Project Name | BCWD Permit 22-18 Stillwater Oaks**Date** | 06/11/2024**To / Contact info** | BCWD Board of Managers**Cc / Contact info** | Jason Palmby, Fairway Estates of Grant / Scott Dahlke, Civil Engineering Site Design**Cc / Contact info** | Karen Kill, Administrator / BCWD**From / Contact info** | Camilla Correll, PE; Ryan Fleming, PE; John Sarafolean / EOR**Regarding** | Permit Application No. 22-18 Amendment and Extension**Applicant:** Jason Palmby, Fairway Estates of Grant**Recommendation:** Approve Permit Amendment and Extension**OVERVIEW**

Project Name | BCWD Permit 22-18 Stillwater Oaks**Date** | 09/08/2023**To / Contact info** | BCWD Board of Managers**Cc / Contact info** | Jason Palmby, Fairway Estates of Grant / Scott Dahlke, Civil Engineering Site Design**Cc / Contact info** | Karen Kill, Administrator / BCWD**From / Contact info** | Camilla Correll, PE; Ryan Fleming, PE; Paul Nation, PE; John Sarafolean / EOR**Regarding** | Permit Application No. 22-18 Engineer's Report

Figure 1: Proposed phasing map.

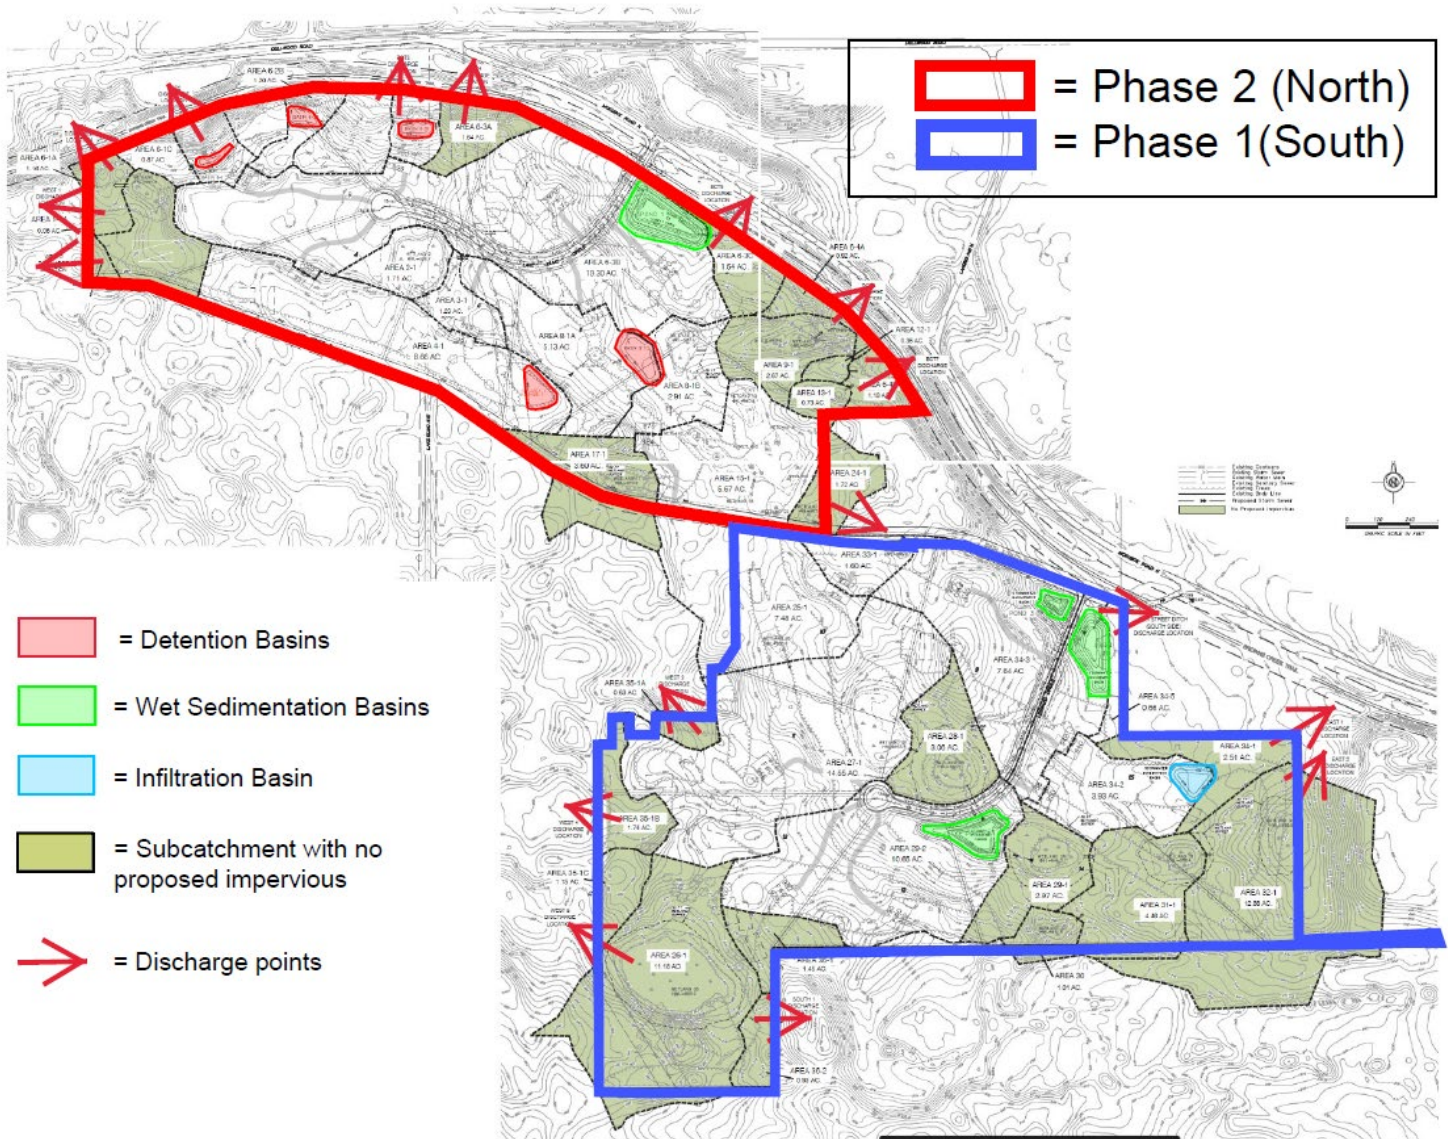
The applicant is requesting an amendment which would allow implementation of the southern portion of the site in a first phase, leaving implementation of the northern portion for a second; i.e., issuance of a permit (22-18A) for implementation of the proposed work on the work south of 88th Street, while the activities north of 88th Street (permit 22-18B) remain conditionally approved. The applicant is also requesting a two-year extension of the permit and the conditional approval.

The project plans and performance of stormwater management facilities were evaluated under the proposed phased construction approach. The two phases are geographically separated by 88th St and located within separate subwatersheds. As shown in the engineer's report for the original application (attached), the stormwater management is proposed separately for each of the south and north phases. The BCWD engineer has verified that the separate construction of phase 1 and phase 2 may proceed independently without causing a further shortfall in compliance with stormwater-management requirements for either phase, and that bifurcation of the project into separate phases does not exacerbate the shortcomings from compliance for either of the two variances approved with the original conditional permit approval. Each phase would have its own access road, stormwater management facilities, and discharge points. The following bullets from the September 2023 engineer's report further describe the proposed phases while Figure 1 illustrates these phases:

If the managers approve the requested amendment, work under phase 1 may proceed as soon as the conditions of approval for that phase have been satisfied. No work on phase 2 may proceed until all conditions on approval of that phase have been satisfied, however the term for the applicant to satisfy the applicable conditions and complete all work on phase 2 would be extended to October 1, 2026.

Figure 1 - Site Plan

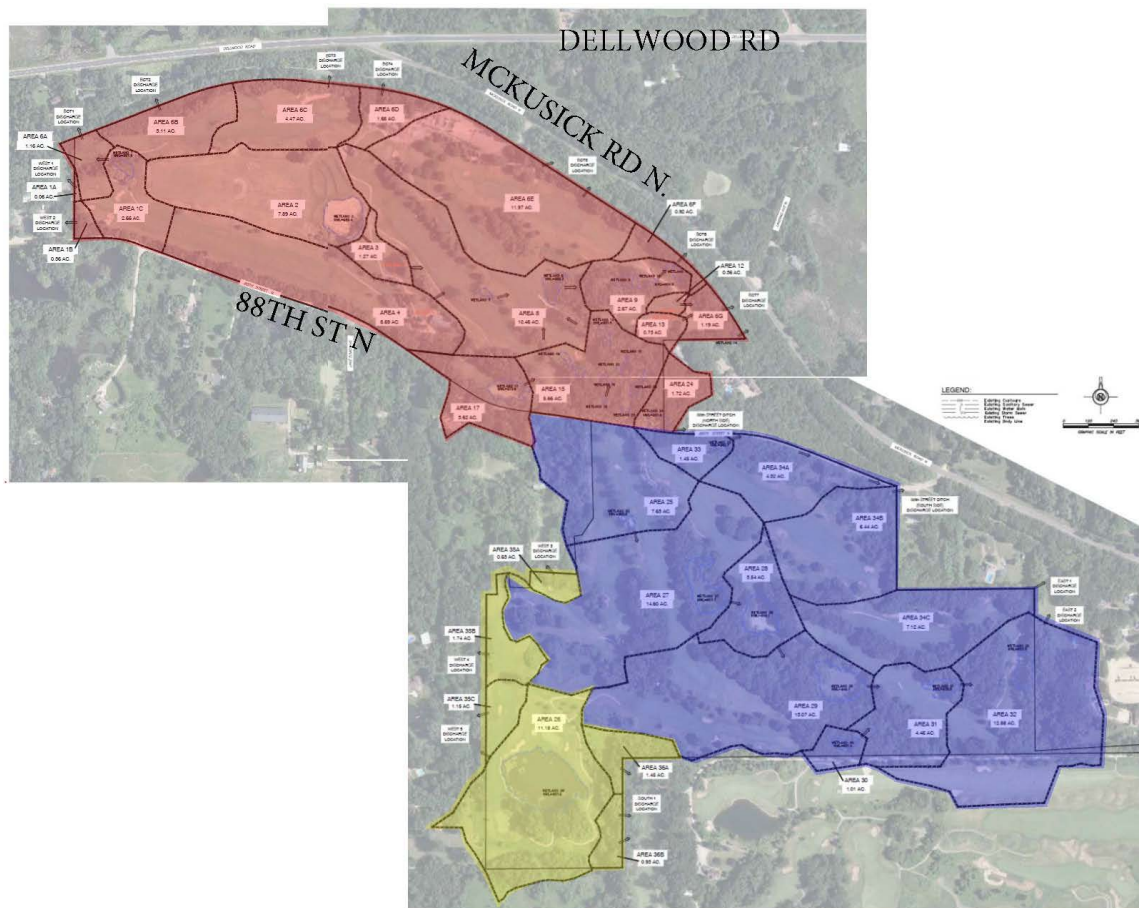
- The northern portion of the site, shaded red on Figure 1, will be subdivided into eight (8) lots. Stormwater runoff from the northern portion of the site will be collected via roadway ditches from the streets, driveways, and front lawns and routed to one stormwater management basin (wet pond) located at the most westerly entrance from McKusick Road. This basin has been designed to capture stormwater runoff for reuse via irrigation. Rear lot drainage is routed to existing wetlands or smaller detention basins (5) designed to meet the stormwater management requirements before discharging to the Brown's Creek State Trail or to the main discharge point under McKusick Road. This portion of the site is subdivided into 26 subwatersheds and includes 24 wetlands. Six of the wetlands were determined to be incidental under the Wetland Conservation Act; that is, not protected under WCA. One wetland is going to be incorporated into a new, larger wetland; the remaining 5 incidental wetlands will remain undisturbed. In addition, 6.5 acres of tree preservation and native vegetation restoration areas will provide volume control through evapotranspiration.

- The southern portion of the site, shaded purple on Figure 1, will be subdivided into seven (7) lots. Stormwater runoff from the southern portion of the site will be collected via roadway ditches from the streets, driveways, and front lawns and routed to three stormwater management basins (wet ponds), two of which are located at the entrance from 88th Street N and one which is located near the entrance road (Leeward Circle) cul-de-sac. One of these basins has also been designed to capture stormwater runoff for reuse via irrigation. Rear lot drainage is routed to existing wetlands and an infiltration basin before discharging east towards Brown's Creek State Trail. In addition, 4.7 acres of tree preservation and native vegetation restoration areas will provide evapotranspiration-based volume control where infiltration is not feasible.

- Stormwater runoff from the southwestern portion of the site, shaded yellow on Figure 1, drains to the larger wetland and the back of the adjacent residential properties. 1.6 acres of tree preservation and native vegetation restoration areas will provide evapotranspiration-based volume control because geotechnical analysis found that infiltration is not feasible.

Figure 3 - Proposed discharge to BCT2

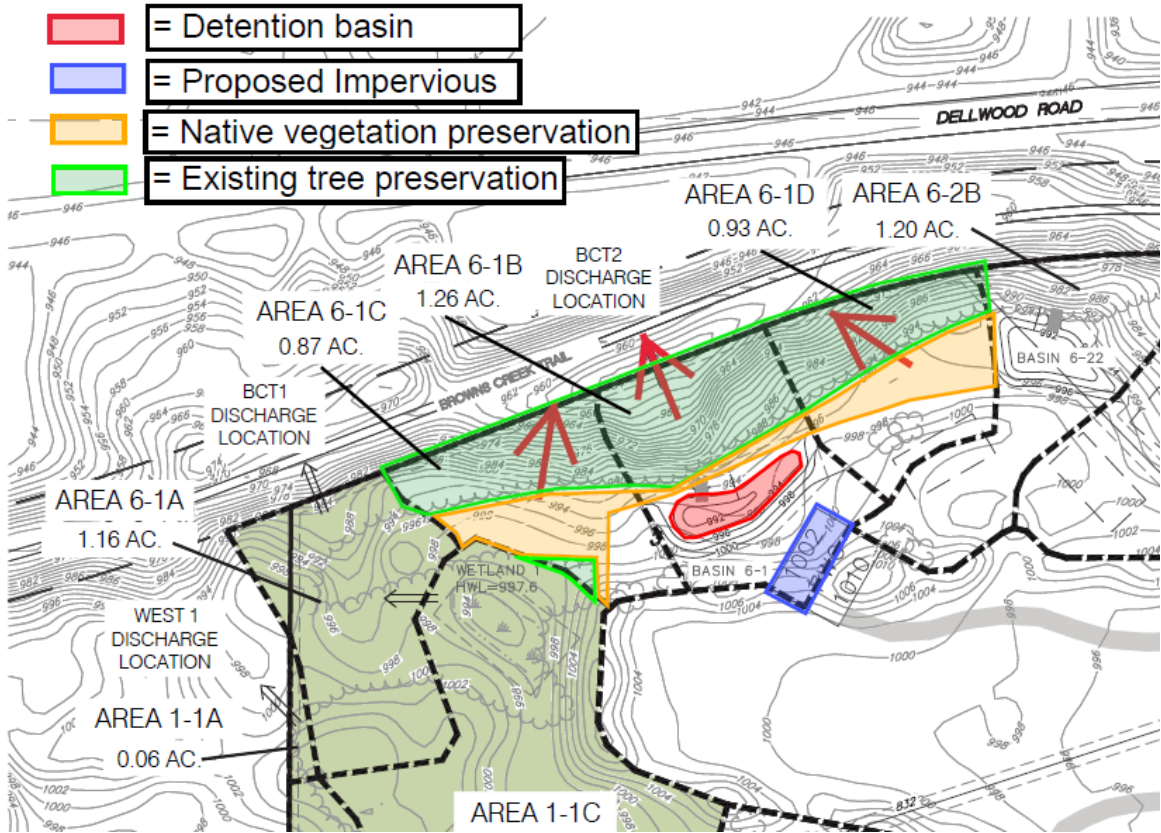
- BCT2 - This discharge point collects drainage from three subcatchments including Area 6-1C, Area 6-1B and Area 6-1D. One of these subcatchments has new impervious coverage associated with the building pad as well as a rate control pond (Area 6-1B). A significant portion of the area is being converted to native vegetation; however, this area is downstream of the rate control pond where infiltration is infeasible due to soil conditions (Refer to Figure 3).
- BCT3 - This discharge point collects drainage from three subcatchments including Area 6-2B, 6-2C, and Area 6-2A. One of these subcatchments has new impervious coverage associated with the building pad. In addition, there are two rate control ponds in this drainage area that discharge to the native vegetation area (Refer to Figure 4).

The subtotals shown in Table 13 indicate locations of common drainage to a downstream resource, e.g., wetland or property. The BCWD engineer finds that there is sufficient data and analysis to support the board's granting the variance from the volume control requirement since the stormwater management plan demonstrates that more volume control is being provided at each of the subtotaled discharge locations than what is currently happening under existing conditions. While two of the discharge points along the vegetated swale (conveyance system) along Brown's Creek State Trail are increasing in volume from existing conditions, there are multiple discharge points along the same conveyance system that discharge less than existing conditions, so that the net discharge at the most downstream end is less than existing conditions overall by 13,786 cubic feet. Given that the net volume being discharged to the vegetated swale is less than existing conditions, there will be no impact to the vegetated swale. Additionally, there will be no impact to the downstream wetland system (as articulated under Rule 2.0). As a result of these evaluations, the BCWD engineer supports the board's granting a variance to the volume control requirement in this instance. Further, the total volume being mitigated via stormwater infiltration, stormwater reuse and evapotranspiration is greater than the volume currently leaving the site in total which also meets the District's goals for groundwater recharge and runoff reduction.
